Access Compliance Report

Public Rights-of-Way

(Curb Ramps)

Intersection ID: 11483	Main Street: E_17TH_ST	Cross Street: N_CALDWELL_ST	Location: N
ADA ID: 70779F61E7AF	Ramp Type: PerpDiag	Initial Pass/Fail: Fail	Overall Compliance: No
			Severity Score: 26.25

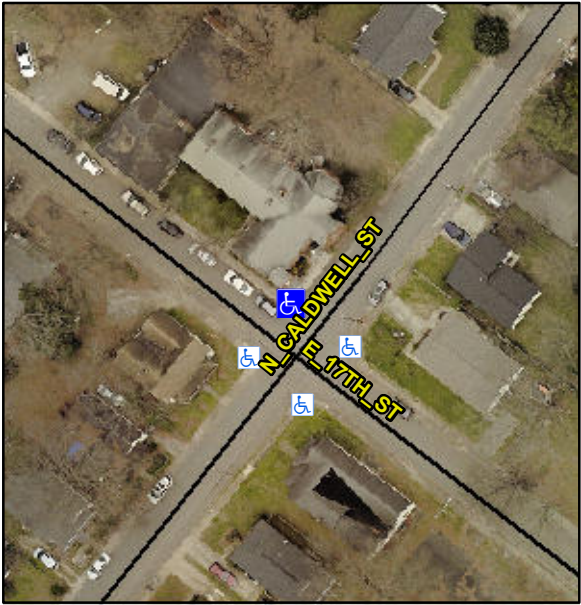
Codes/Mitigation Info/Possible Solution			Field Measurements/Component Compliance		
	Possible Solutions:		Compliance	Description	Data
	Remove & Replace Curb Ramp With Two New Directional Ramps or Equivalent.		N/A	Ramp Length (in)	66.0
			Yes	Ramp Width (in)	65.0
			N/A	Flare Type LT	N/A
			N/A	Flare Slope LT (%)	N/A
			N/A	Flare Traversable LT?	N/A
			N/A	Landing Length (in)	N/A
			N/A	Landing Width (in)	N/A
			N/A	Landing Slope (%)	N/A
			N/A	Landing X Slope (%)	N/A
<p>Surveyor Notes:</p> <p>N/A</p> <p>PROW/ADA:</p> <p>R304.2.2, R304.5.3</p>			N/A	Flare Type RT	N/A
			N/A	Flare Slope RT (%)	N/A
			N/A	Flare Traversable RT?	N/A
			N/A	DWS Provided?	N/A
			N/A	DWS Contrast?	N/A
			N/A	DWS Length (in)	N/A
			N/A	DWS Full Width?	N/A
			N/A	DWS Offset (in)	N/A
			N/A	Shared Landing?	N/A
			N/A	Gutter Ponding?	N/A
			N/A	Gutter Lip Ht (in)	1.0
			N/A	Painted X Walk1?	No
				X Walk 1 Direction	To SW
			N/A	X Walk 1 Width (in)	N/A

X Walk 1 Slope (%)	2.5
				X Walk 1 X Slope (%)	2.0
			N/A	Ramp inside XWalk1?	N/A
				Road Slope (%)	1.4
				Road X Slope (%)	4.5
			N/A	Any Obstructions?	N/A
				Obstruction Type	
Total Cost:		\$ 3200.00
